**Consultation Response from KC,
Conservation & Design****2023/91173 & 2023/91174 - 749, New Hey Road, Outlane, Huddersfield, HD3 3YL****Conversion and extension of existing Listed barn to form one dwelling, alterations to existing farmhouse with associated car parking and external works [Listed Building].****Listed Building Consent for partial demolition, conversion and extension of existing Listed barn to form one dwelling, alterations to existing farmhouse with associated car parking and external works [Listed Building].****Date Responded: 05.06.2023****Responding Officer: Sebastian Pickles****Responding Ref:**

SOUTH WEST ELEVATION

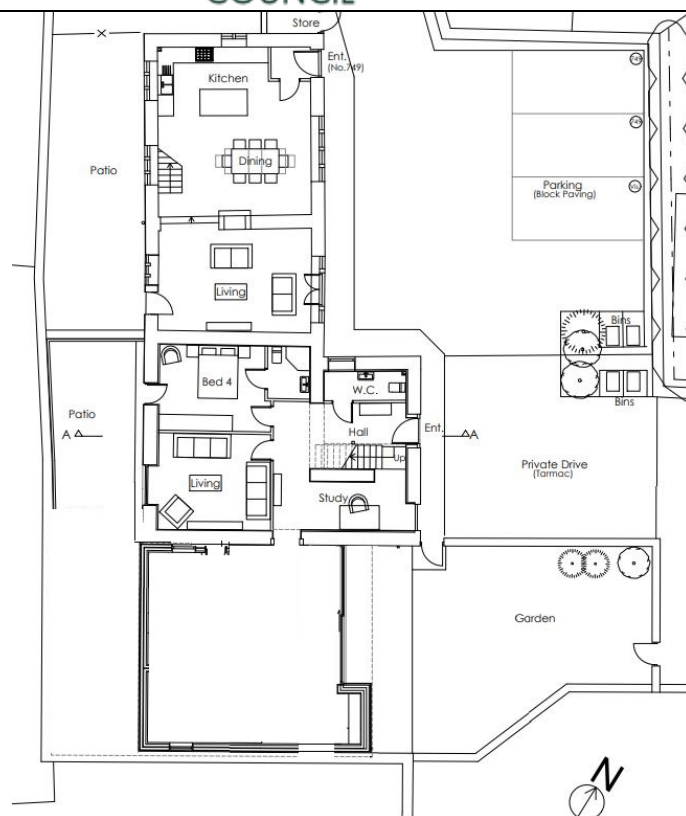
To the west, north-western elevation there are a number of proposed new openings to be created. We in part understand the reasoning behind this, however, this has not been made clear in the submitted details. While the elevation is less visible, it does form a part of the historic character and development of the building. The proposed insertions appear to be trying to create a design which is squeezing in too many window openings to the elevation. We consider that the door openings are acceptable, as these work off the existing openings from the extension which is to be removed. We however do not support the addition of more windows to the left-hand side of the central door. There is no precedent for this opening. We consider these windows need to be omitted from the plans. Plan below for reference.

The design for the doors also requires further consideration as the proposed design is incongruous to the character of the building. We also consider the proposed new window openings on the first floor to be acceptable.
